**DCON(H)/09/1283**

**Land NW Of Haverhill, Anne Sucklings Lane, Little Wratting**

**Application to Discharge Conditions A2 (Alignment), A4 (Arboricultural Method Statement), A5 (Soft Landscaping) , A6 (Landscape and Ecological Management Plan), A8 (Archaeology) and A9 (Excavation and Ground Levels) of SE/09/1283**

The buffer zone is shown on the accompanying plan

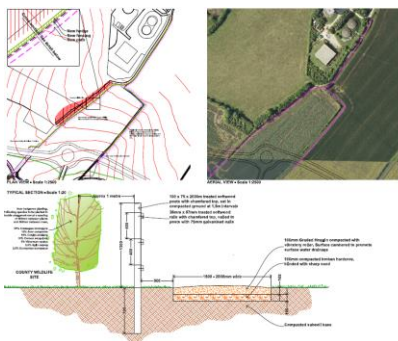
The landscape and open space strategy (September 2010) submitted as part of application SE/09/1283 explains that a *buffer zone will form a green corridor along the north of the proposed Relief Road with an additional area of space to the north of the central roundabout and to the south of Ann Suckling Way County Wildlife Site*. It goes on to say that this buffer zone *will incorporate different types of native and natural planting to aid the integration of the development, and the new edge of the town, into the wider landscape and to provide wildlife habitat to reinforce that within Ann Suckling Way County Wildlife Site*. Key objectives are set out as:

- *To provide a visual buffer around the Relief Road and the new development edge;*
- *To provide a landscape buffer between the Relief Road and the County Wildlife Sites;*
- *To provide an additional public right of way to remove pressure from Ann Suckling Way and the County Wildlife Site;*
- *To create an additional area of calcareous grassland to increase the amount of that habitat available and to bolster the County Wildlife Site;*
- *To preserve the existing hedgerows;*
- *Increase the wildlife habitat and landscape resource.*
